<b>Product / Process Change Notification (PCN)</b>					
<input type="checkbox"/> Major Change <input checked="" type="checkbox"/> Minor Change					
<b>PCN Number:</b> PCN_IndHCI_20250206  <b>Affected Series:</b> WE-HCI  <b>Affected Part Numbers:</b> See table below.  <b>PCN Date:</b> 2024-11-06 (YYYY-MM-DD) <b>Effective Date:</b> 2025-02-06 (YYYY-MM-DD)	<b>Change Category:</b> <input type="checkbox"/> Equipment/Location <input checked="" type="checkbox"/> General Data <input type="checkbox"/> Material <input type="checkbox"/> Process <input type="checkbox"/> Product Design <input type="checkbox"/> Shipping/Packaging <input checked="" type="checkbox"/> Supplier <input type="checkbox"/> Software				
<b>Contact:</b> Product Management  <b>Phone:</b> +49 (0) 7942 - 945 5001  <b>Fax:</b> +49 (0) 7942 - 945 5179  <b>E-Mail:</b> pcn.eisos@we-online.com	<b>Datasheet Change:</b> <input checked="" type="checkbox"/> Yes <input type="checkbox"/> No  <b>Attachment:</b> <input type="checkbox"/> Yes <input checked="" type="checkbox"/> No

**Details of Change:**

The datasheet drawing and the product marking description will change as shown below:

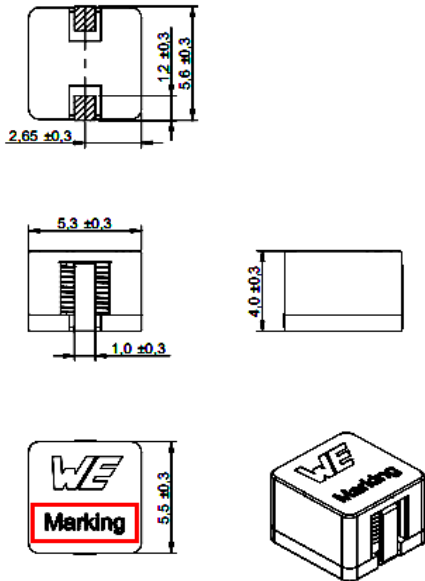
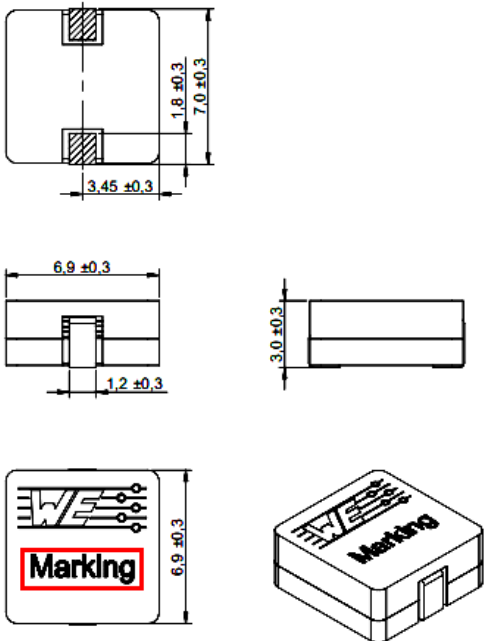
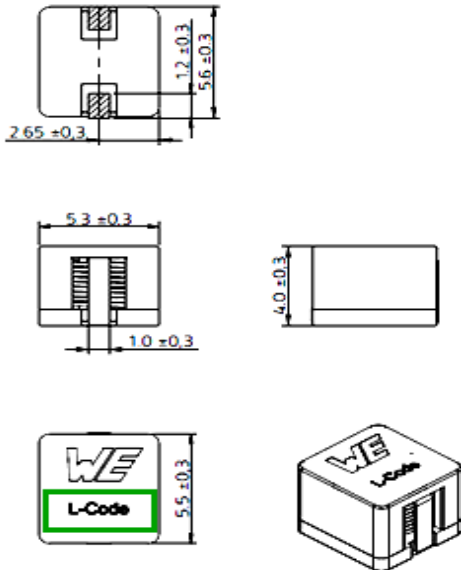
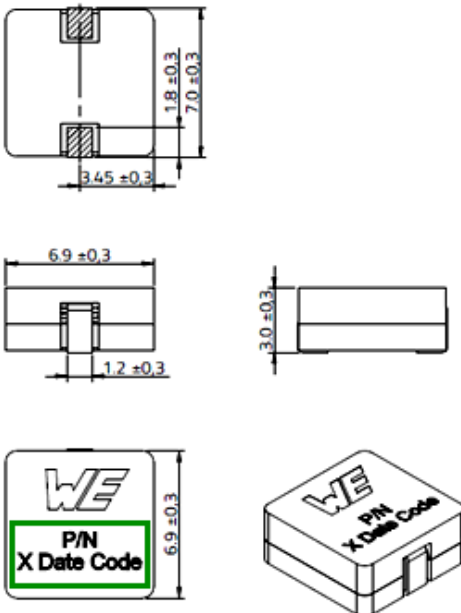
Before change	After change		
<p><b>Sizes: 5040</b></p> <p><b>Dimensions: [mm]</b></p>  <p style="text-align: right;">Scale - 4:1</p> <p><b>Size: 7030, 7040, 7050, 1030, 1040, 1050, 1335, 1350, 1365, 2212, 1890</b></p> <p><b>Dimensions: [mm]</b></p>  <p style="text-align: right;">Scale - 4:1</p>	<p><b>Size: 5040</b></p>  <p style="text-align: right;">Scale - 4:1</p> <p><b>Product Marking:</b></p> <table border="1" style="width: 100%; border-collapse: collapse;"> <tr> <td style="border: 2px solid green; padding: 2px;">Marking L-Code</td> <td style="border: 2px solid green; padding: 2px;">Inductance Value</td> </tr> </table> <p><b>Size: 7030, 7040, 7050, 1030, 1040, 1050, 1335, 1350, 1365, 2212, 1890</b></p>  <p style="text-align: right;">Scale - 4:1</p>	Marking L-Code	Inductance Value
Marking L-Code	Inductance Value

<b>Product Marking:</b> <table border="1" style="border: 2px solid red;"> <tr> <td>Marking</td> <td>X YMDD X</td> </tr> <tr> <td>Marking</td> <td>X (may be changed)</td> </tr> <tr> <td>Marking – Date Code</td> <td>YMDD</td> </tr> </table>	Marking	X YMDD X	Marking	X (may be changed)	Marking – Date Code	YMDD	<b>Product Marking:</b> <table border="1" style="border: 2px solid green;"> <tr> <td>Marking P/N</td> <td>Part Number</td> </tr> <tr> <td>Marking X</td> <td>Internal use only</td> </tr> <tr> <td>Marking Date Code</td> <td>YMDD</td> </tr> </table>	Marking P/N	Part Number	Marking X	Internal use only	Marking Date Code	YMDD
Marking	X YMDD X												
Marking	X (may be changed)												
Marking – Date Code	YMDD												
Marking P/N	Part Number												
Marking X	Internal use only												
Marking Date Code	YMDD
